REMARKS

Inventor: Mark Crockett et al.
Serial No.: 10/617,950
Title: Micromachined, Integrated Fluid Delivery System . . .
Docket No.: AM-6051.P1
Phone: S. L. Church
Page 1 of 18
(650) 473-9700

Fig. 1

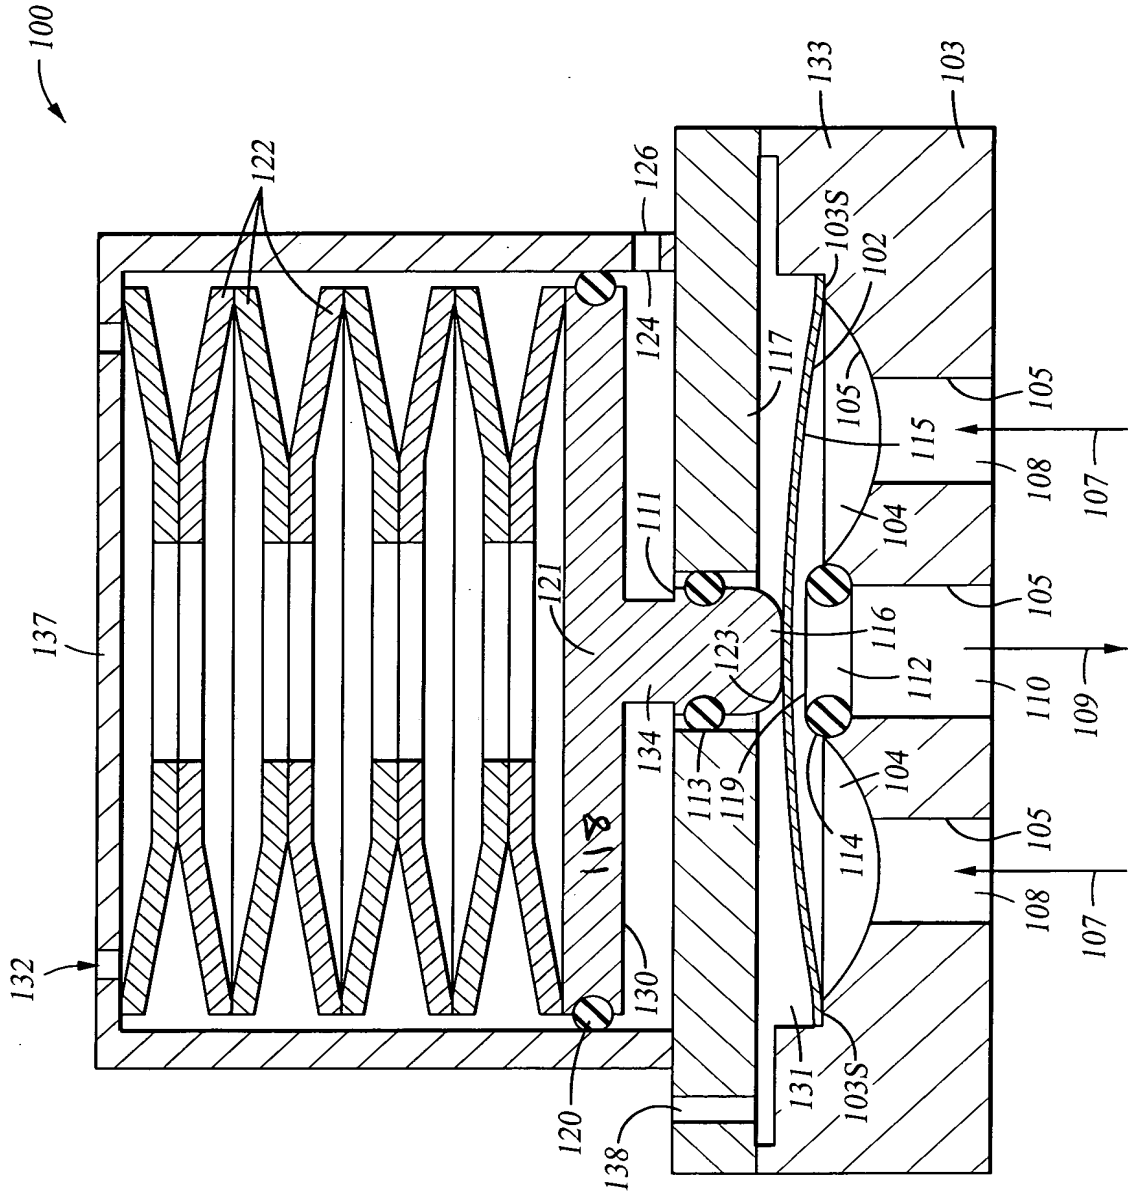
In particular, Figure 1 on Sheet 1 has been amended to include reference numeral 118, which refers to the upper horizontal member of sliding cylinder 121. This corresponds with upper horizontal member 318 of sliding cylinder 321 in Figure 3, for comparison purposes. Paragraph [0069] of applicants' specification has been amended, as set forth above, to include reference to upper horizontal member 118 and vertical member 134 (which was numbered, but was not previously referenced in the specification). The amendments to Figure 1 and to Paragraph [0069] are supported at page 7, lines 4 - 6, of Paragraph [0023] of applicants' originally filed specification.

[0069] The sliding cylinder 121 has an upper horizontal member 118 connected to a smaller, lower horizontal member 116 by a vertical member 134. When the valve 100 is in the closed position, the fluid flow is interrupted by a section of the diaphragm 102 being pressed tightly against an upper surface 119 of the metal valve seat 114 by lower horizontal member 116 of sliding cylinder 121. The lower surface 123 of lower horizontal member 116 is convex-shaped, so that it can act as a backing disk behind diaphragm 102. Lower horizontal member 116 is considered to be part of drive section 106, since lower horizontal member 116 is not wetted by fluids passing through valve 100. The diaphragm 102 may be free-moving, or may be bonded to the convex surface 123 of lower horizontal member 116, for example, by e-beam welding, or direct bonding, or other bonding techniques known in the art. The convex surface 123 of lower horizontal member 116 which contacts diaphragm 102 is typically made of a material which has a hardness less than that of the diaphragm material. If the diaphragm 102 is made of a nickel-cobalt alloy (for example, and not by way of limitation, ELGILOY®, SPRON™ 510, SPRON™ 100, HASTELLOY®, or

Fig. 10

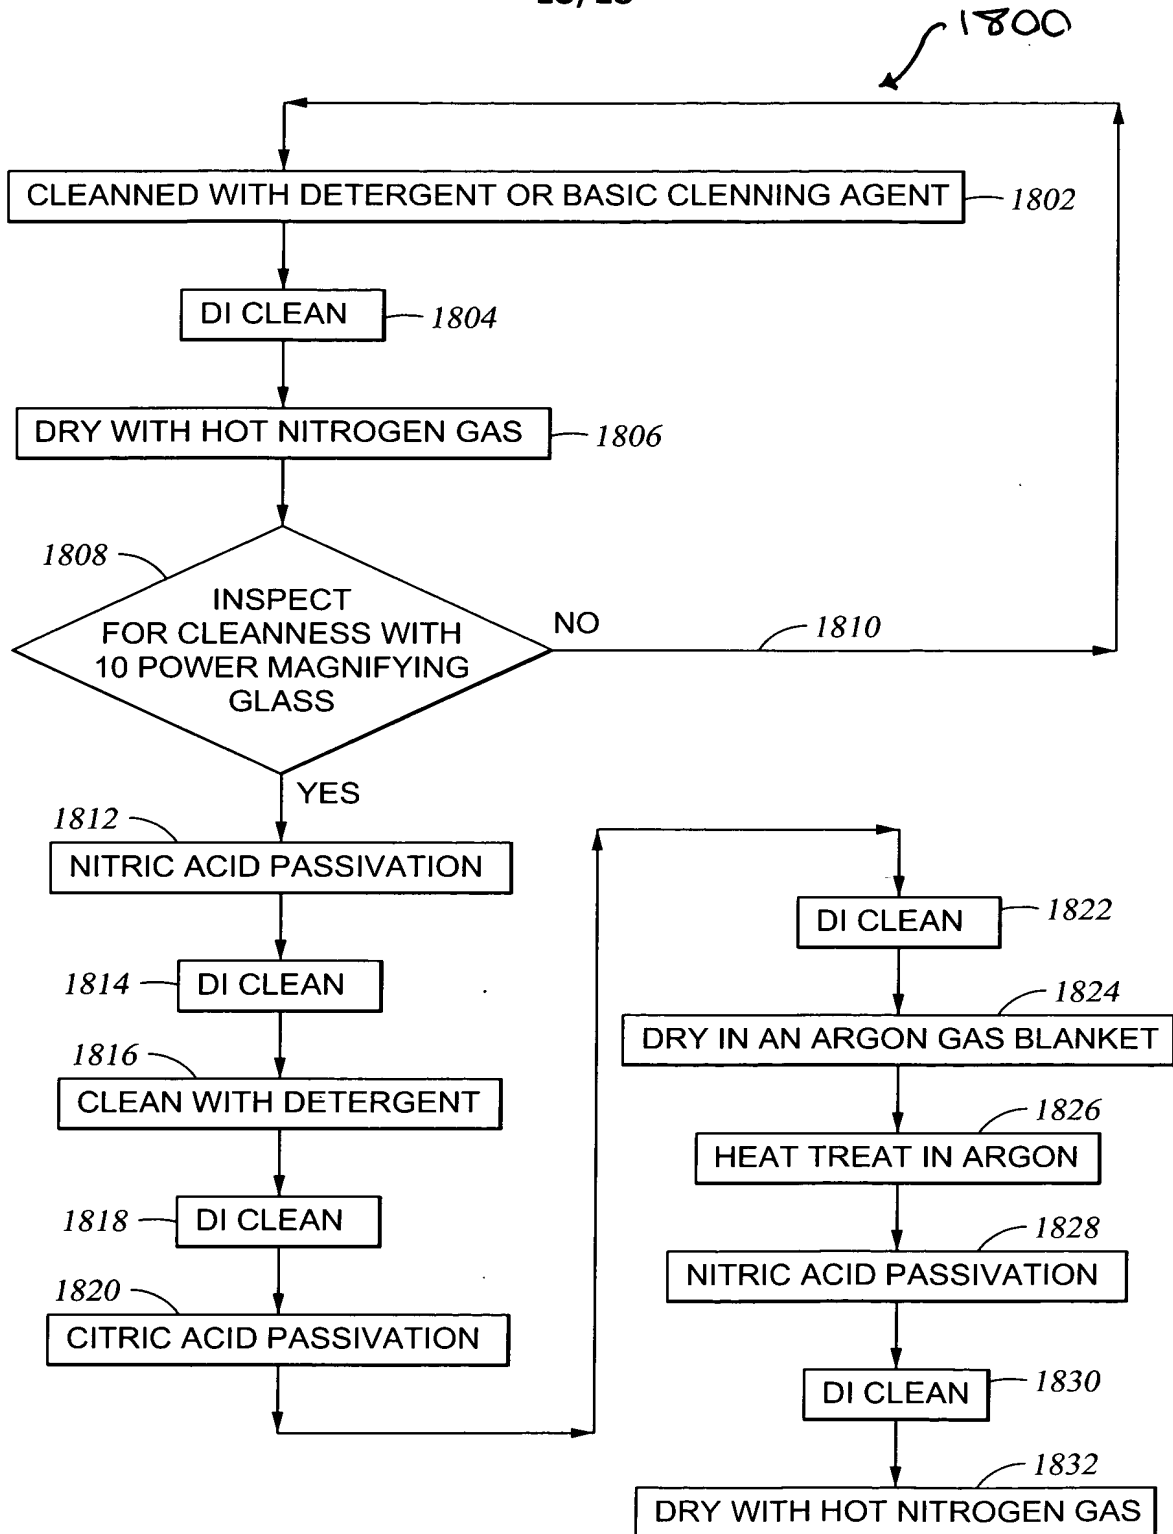
Figure 10 on Sheet 18 has been amended to include reference numeral 1800, which refers to the process diagram for the stainless steel treatment method. The amendment to Figure 10 is supported at page 31, lines 11 - 13, of Paragraph [0106] of applicants' originally filed specification.
